ADDENDUM NUMBER ONE

Bids Received until
2:00 P.M. CDT November 17, 2011
Hoover City Schools Board of Education
2810 Metropolitan Way
Hoover, Alabama 35243

Harold L. Foshee Architects
345 Highgate Hill
Indian Springs,
Alabama 35124

**ADDITIONS TO
HOOVER HIGH SCHOOL
HOOVER, ALABAMA**

Revise Drawing Sheet No. A6.1

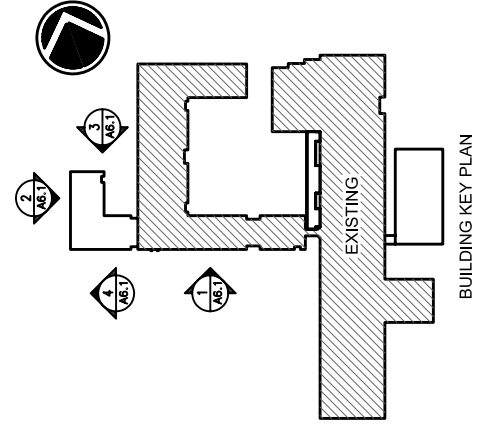
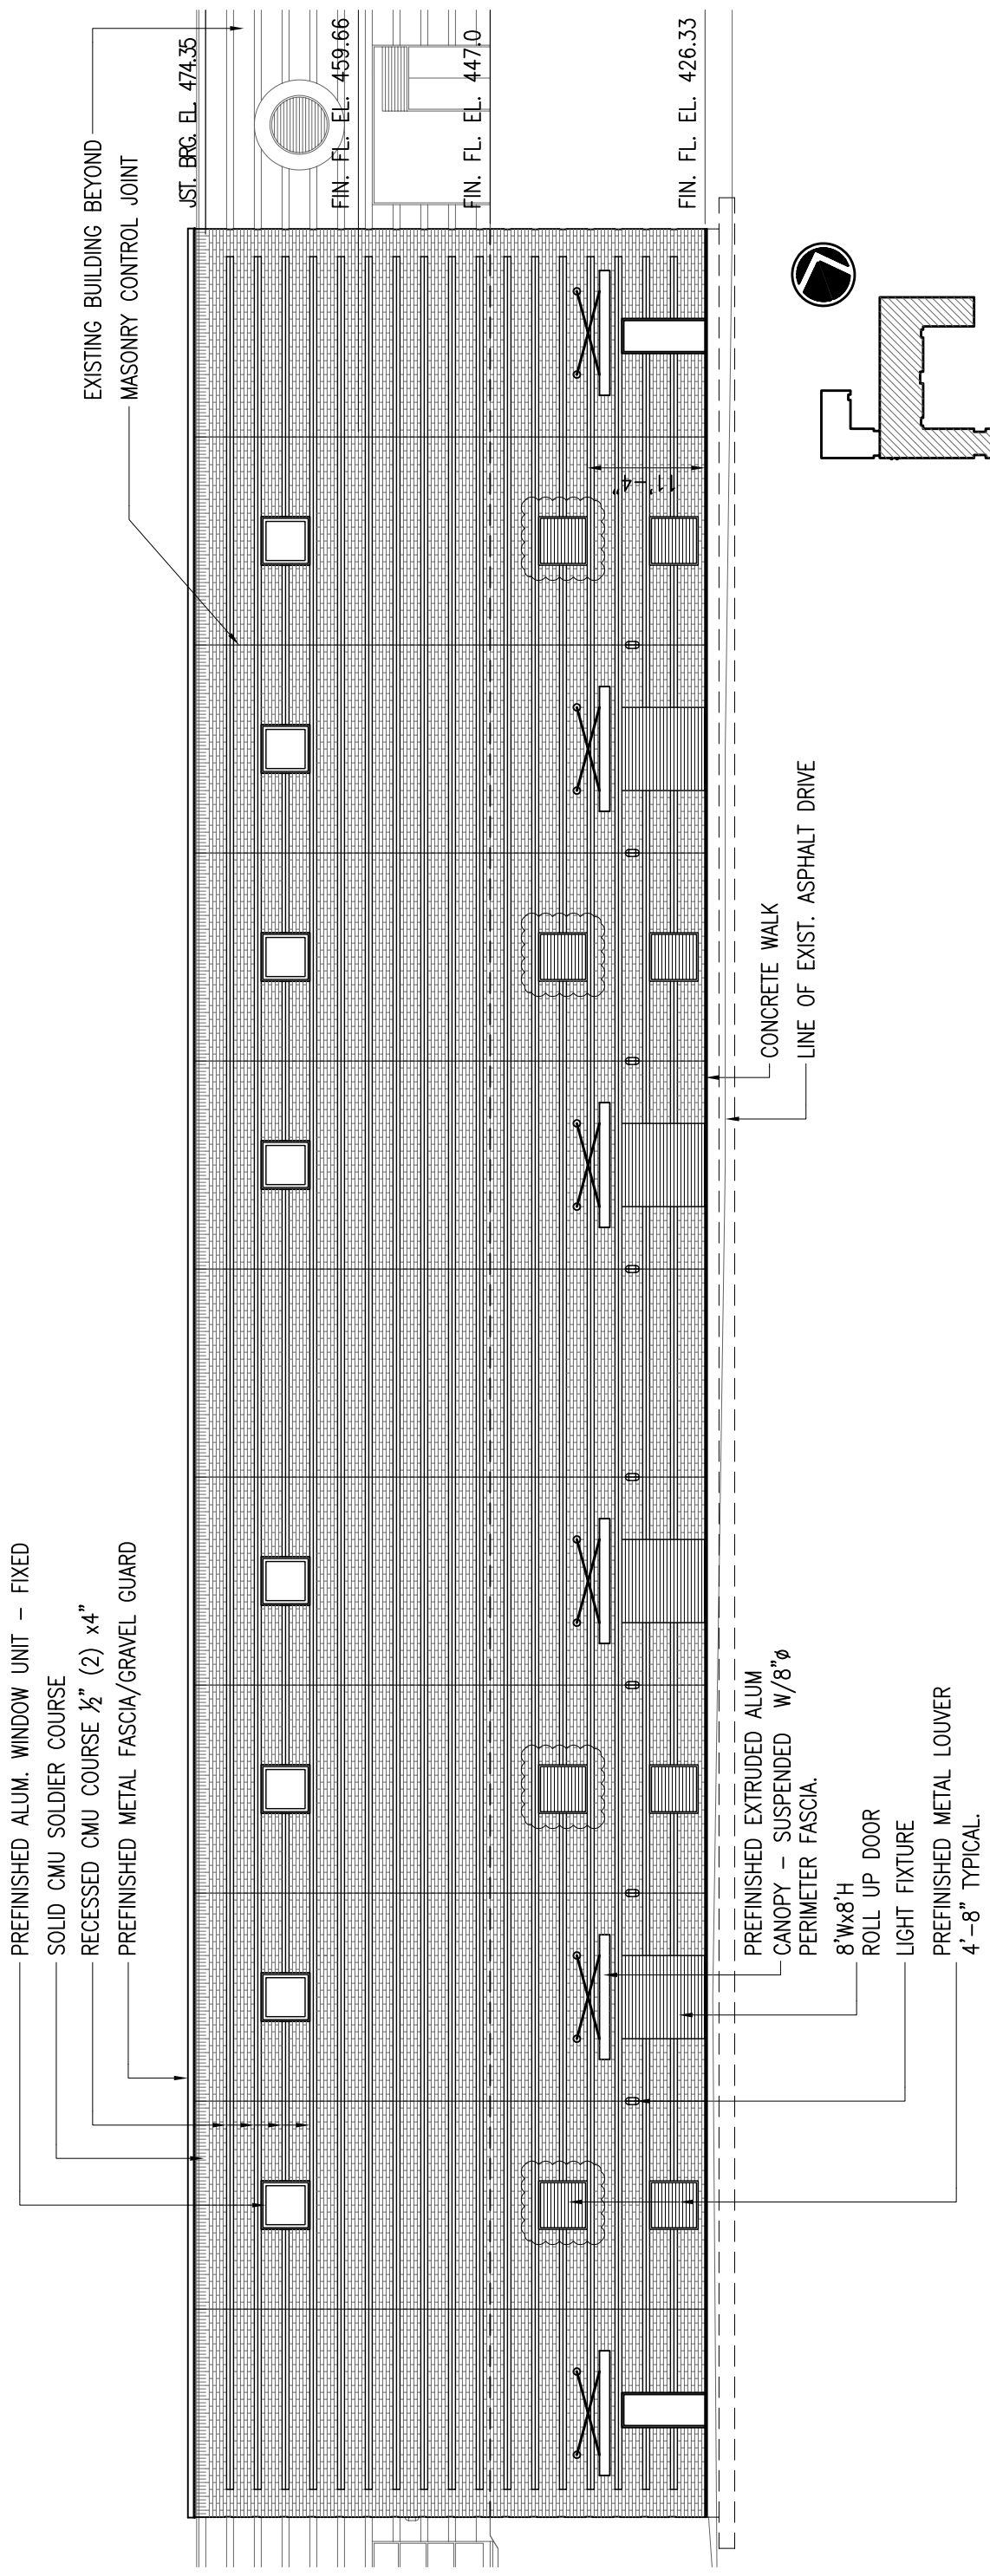
D1.1 Sheet No. A6.1:

A. Revise drawings as shown. See Attachments SD-1 and SD-2.

Revise Drawing Sheet No. A6.2

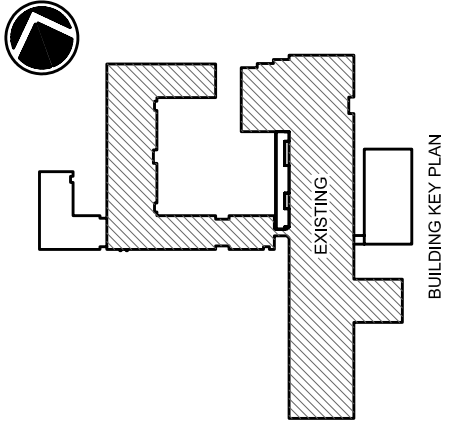
D1.2 Sheet No. A6.2:

A. Revise drawings as shown. See Attachment SD-3.

Revise Drawing Sheet No. A2.1, A2.2, A2.3

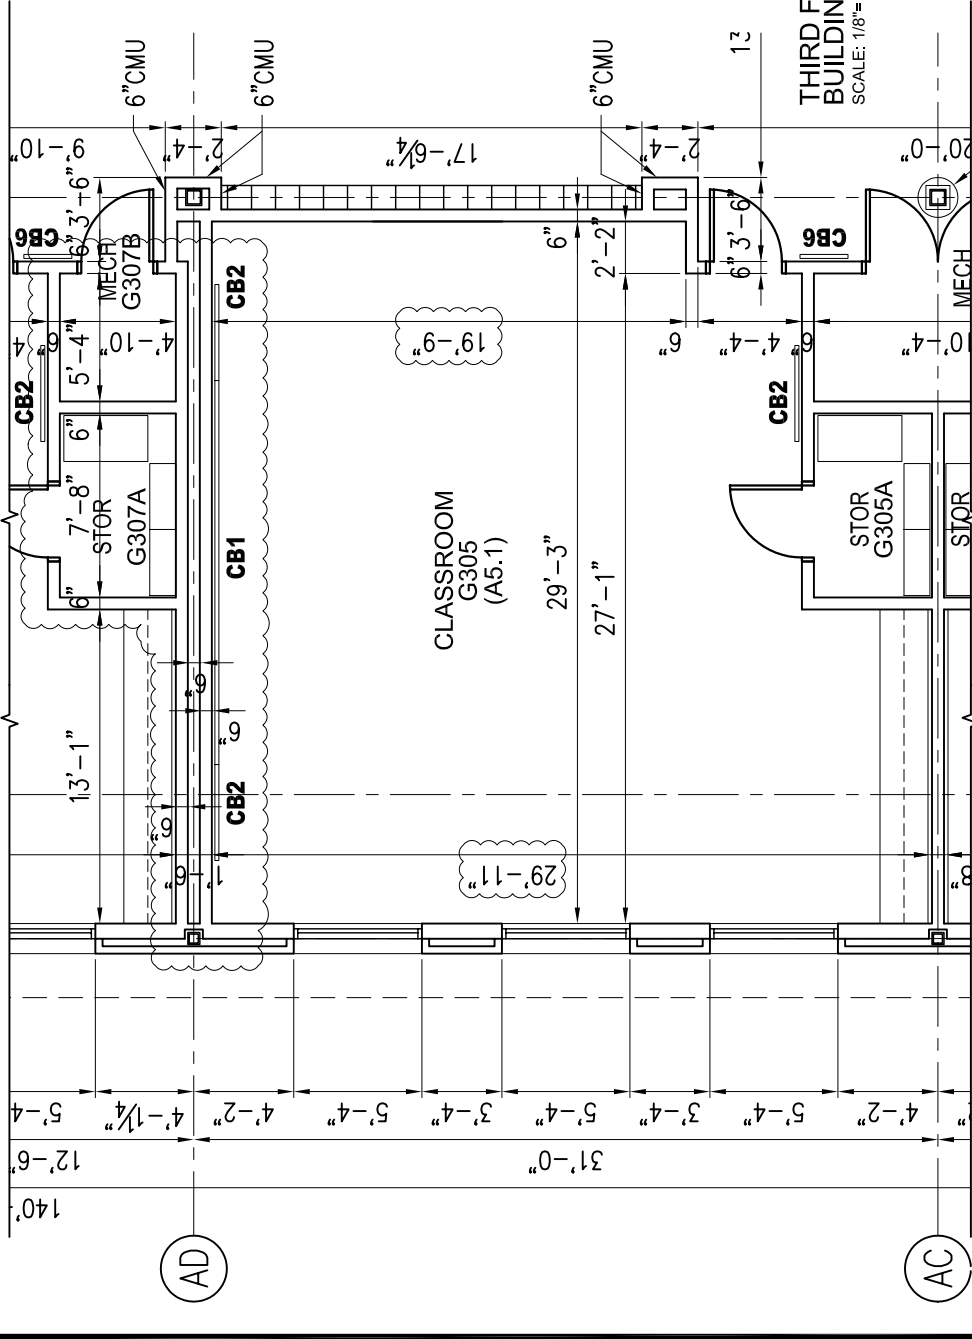
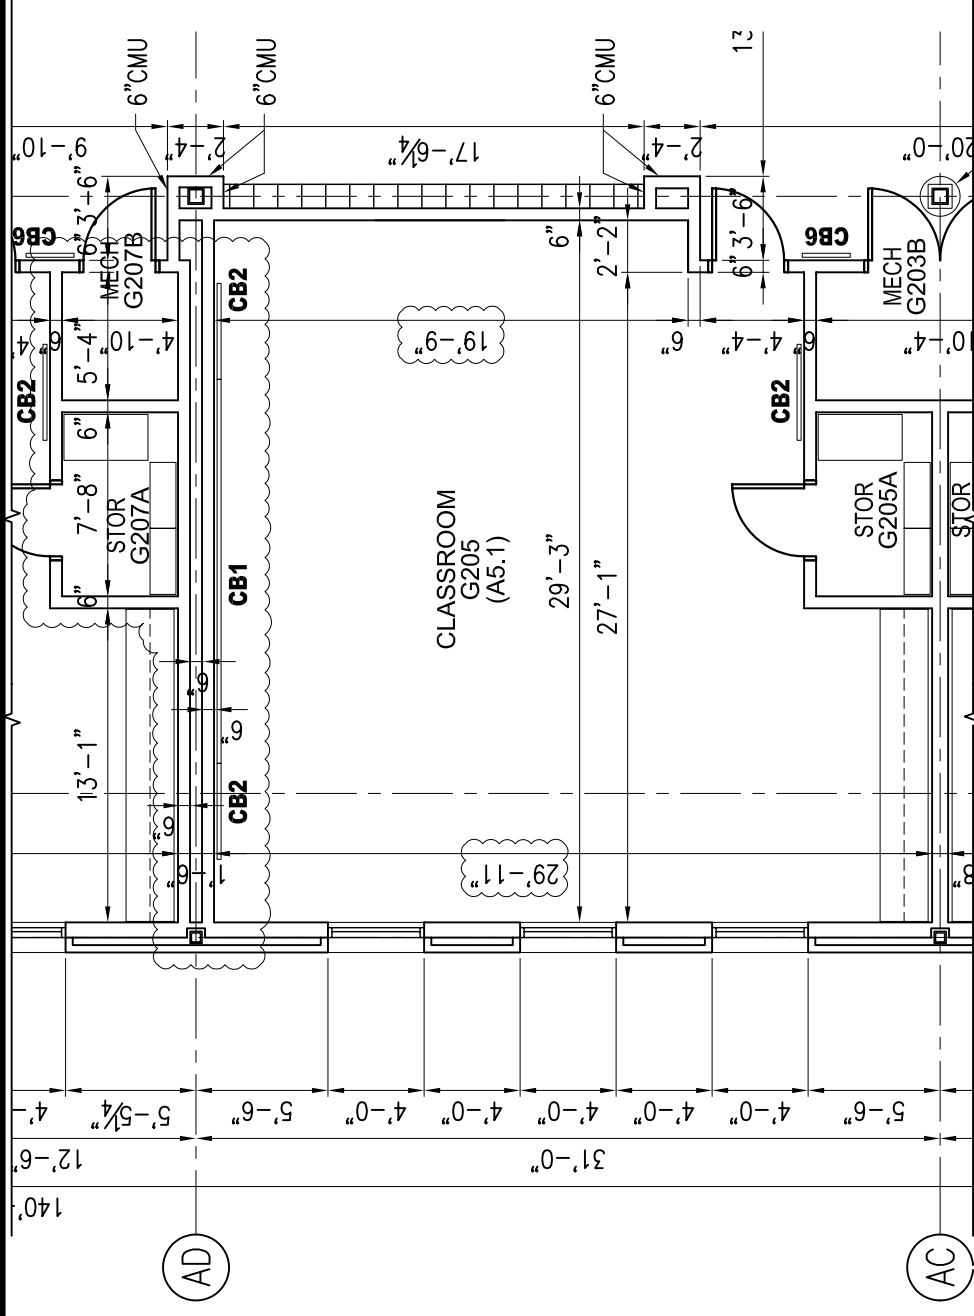
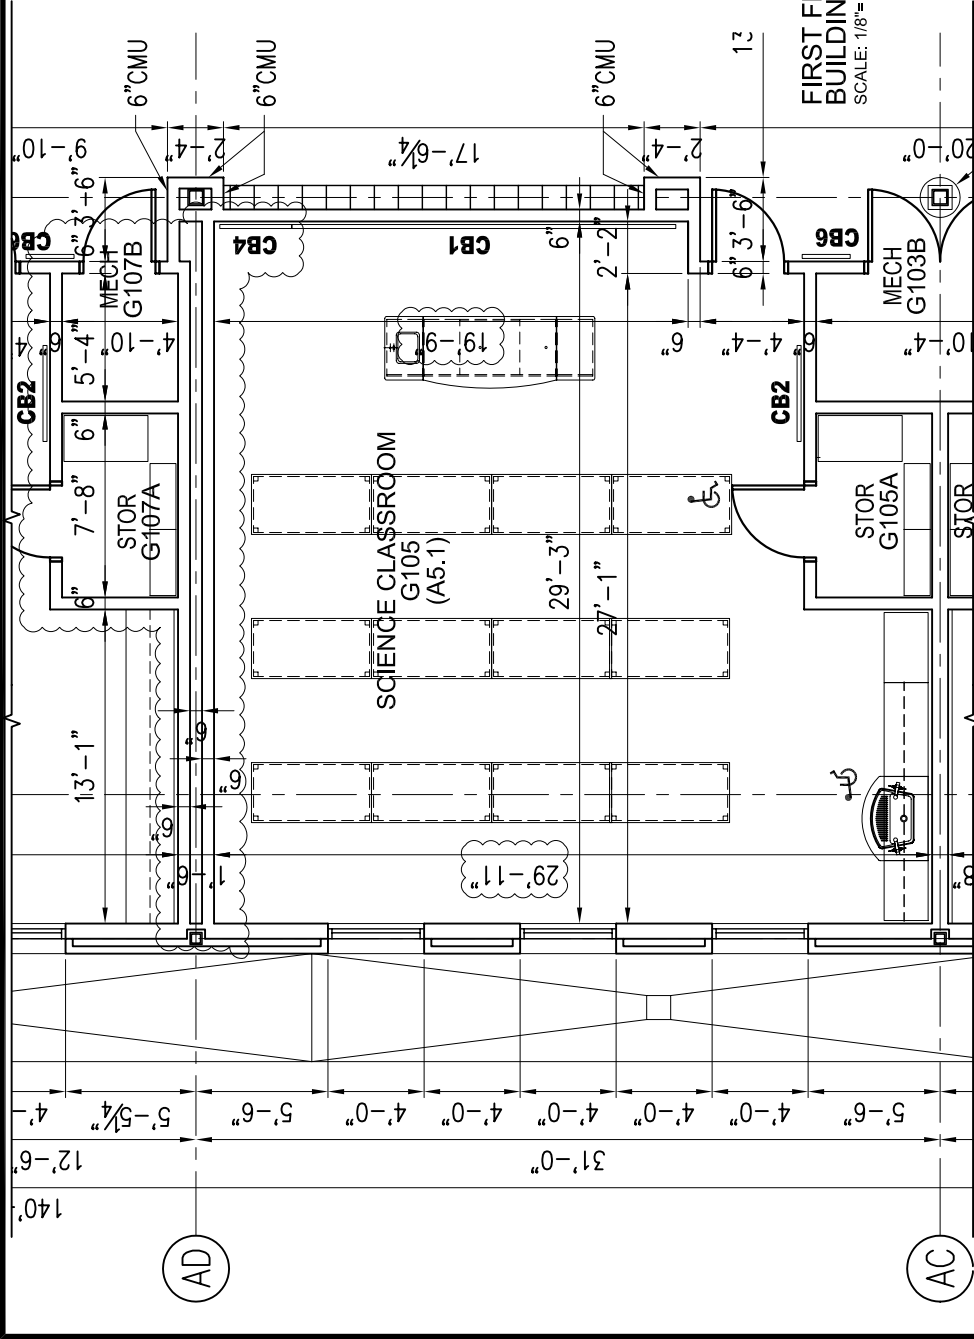
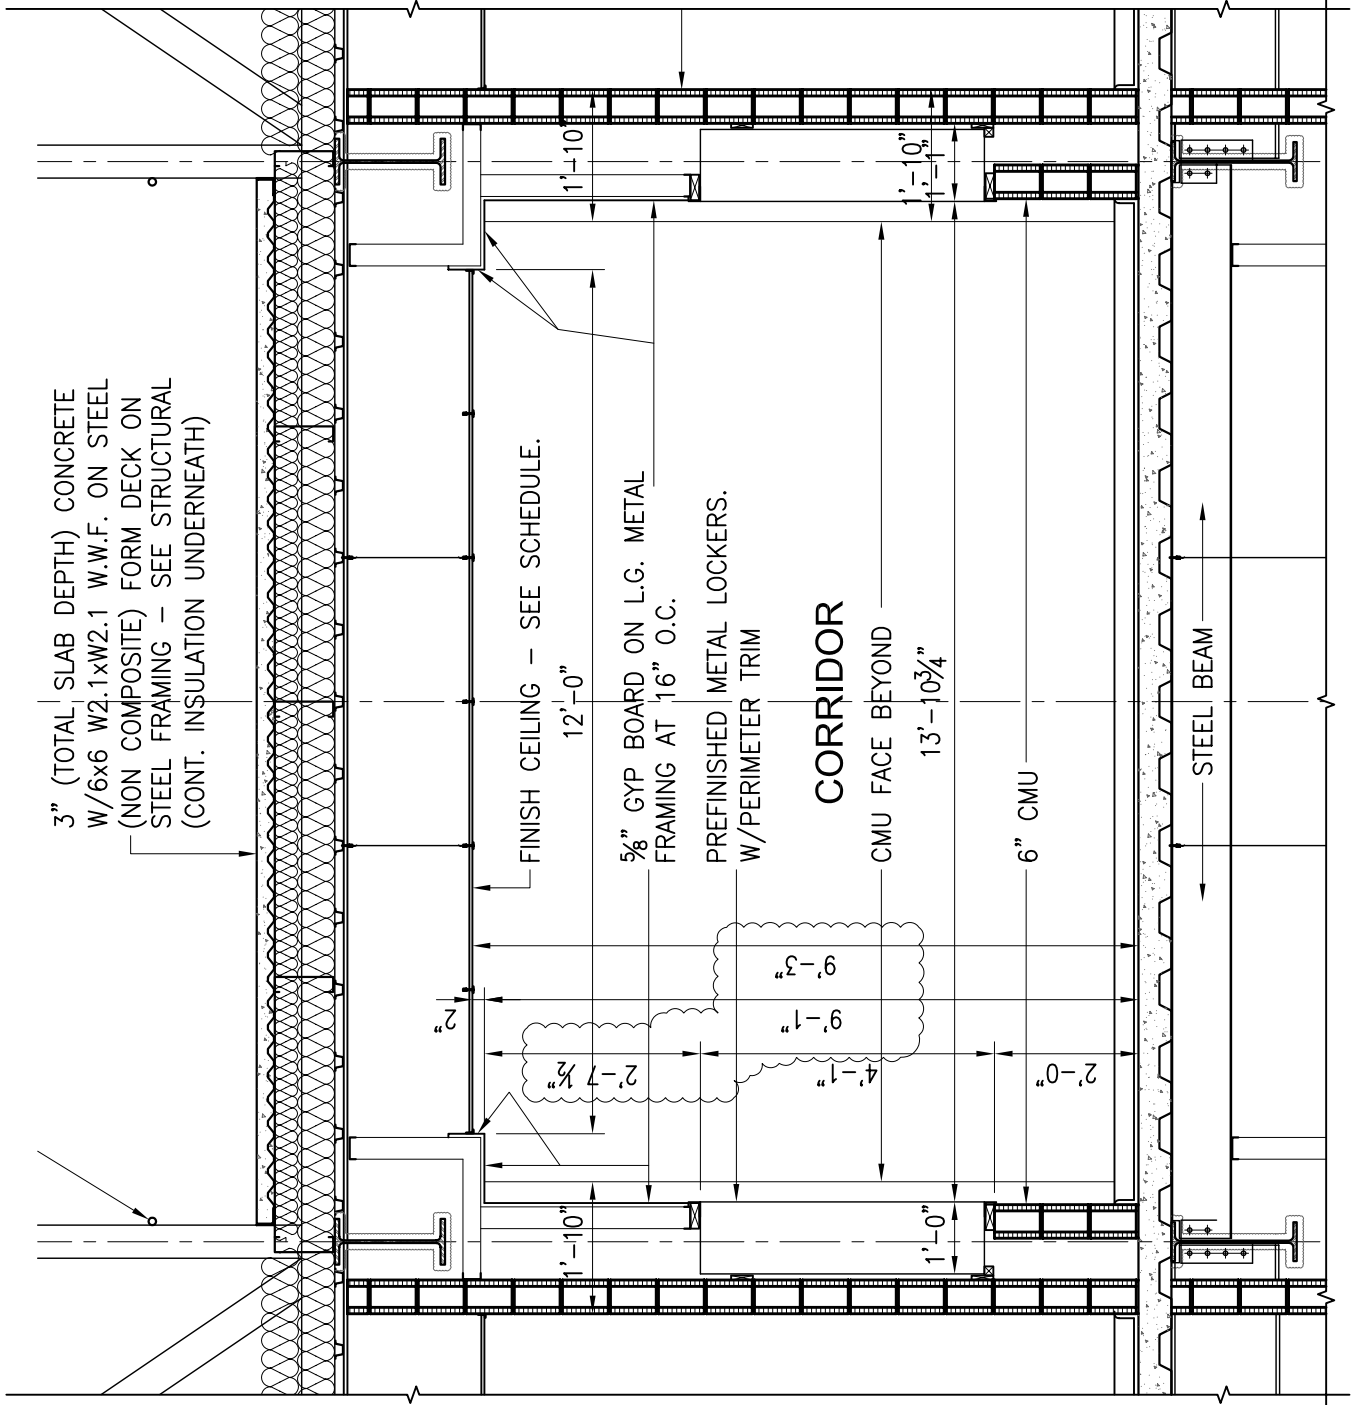
D1.3 Sheet No. A2.1, A2.2, A2.3, A3.1, A5.1:

A. Added double walls at Column AD and between Columns 1' & 2. See Attachment SD-4 & SD-7.
